TECHNISCHE INFORMATION NR. SI36-066

SERVICE INFORMATION NO. SI36-066

Airworthiness Directives; Various Aircraft Equipped With Rotax Aircraft Engines 912 A Series Engine

REPLACEMENT OF WASHER PART NO. 944072 (FLY WHEEL HUB) FOR ROTAX® ENGINE TYPE 912 AND 914 (SERIES)

Fig. 1

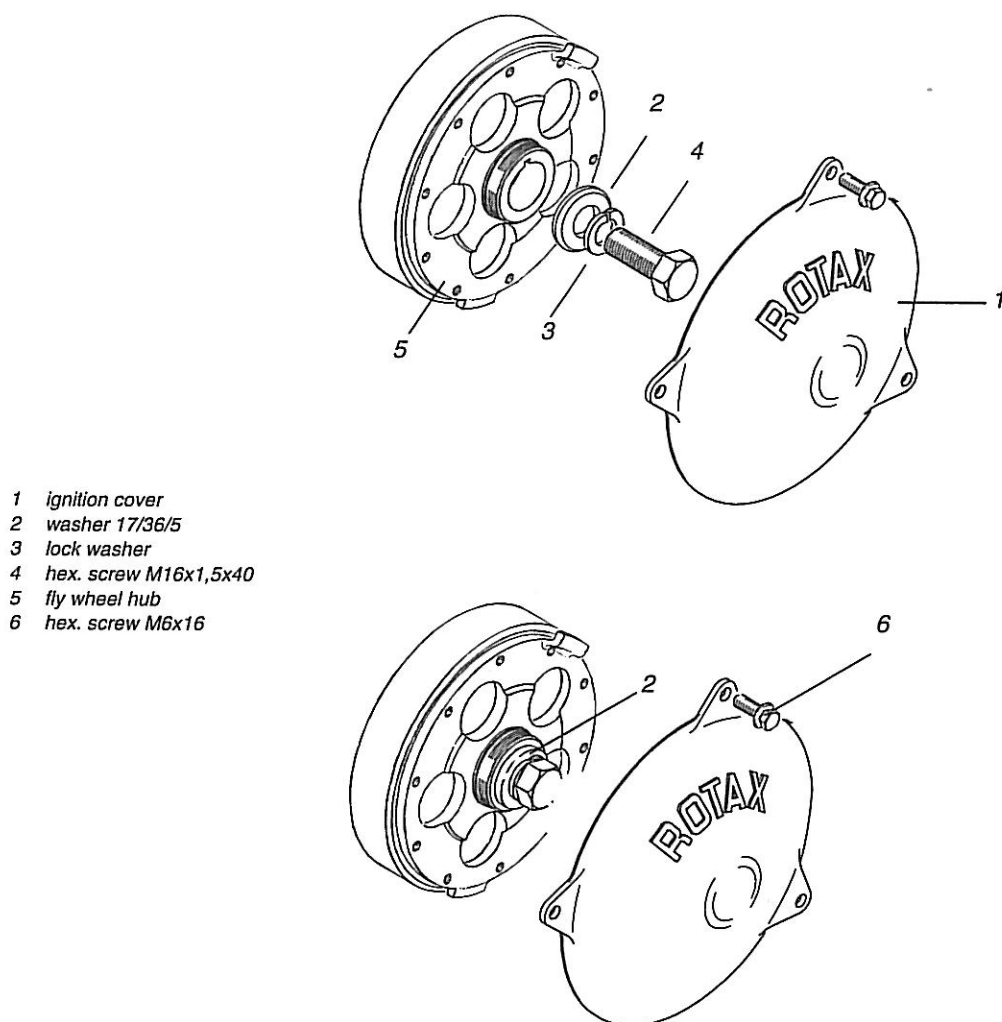
A deviation in hardening process could cause an exceeding of hardness of certain washer. This deviation could lead to cracks in the washer and could cause loosening of fly wheel, ignition failure or engine damage.

1. Remove ignition cover (1).
2. Lock the crankshaft in accordance with the relevant Maintenance Manual (Line).
3. Remove hex. screw (4) in accordance with the relevant Maintenance Manual (Heavy).

■ CAUTION: If the fly wheel hub has loosened during the disassembly and/or in case of doubt, then remove, clean and install the fly wheel hub in accordance with the relevant Maintenance Manual. In this case the tightening torque is 45 Nm (33.2 ft.lb) + 180° angle to rotation.

4. Install hex. screw (4). **Tightening torque 120 Nm (89 ft.lb).**

■ CAUTION: During installation the new washer (2) part no. 944072 must be used.

5. Remove locking pin of crankshaft in accordance with the relevant Maintenance Manual.
6. Check trigger coil gap, if necessary adjust it in accordance with the relevant Maintenance Manual.
7. Install ignition cover (1). The hex. screws (6) are locked with Loctite 221. Tightening torque 5 Nm (44 in. lb.).
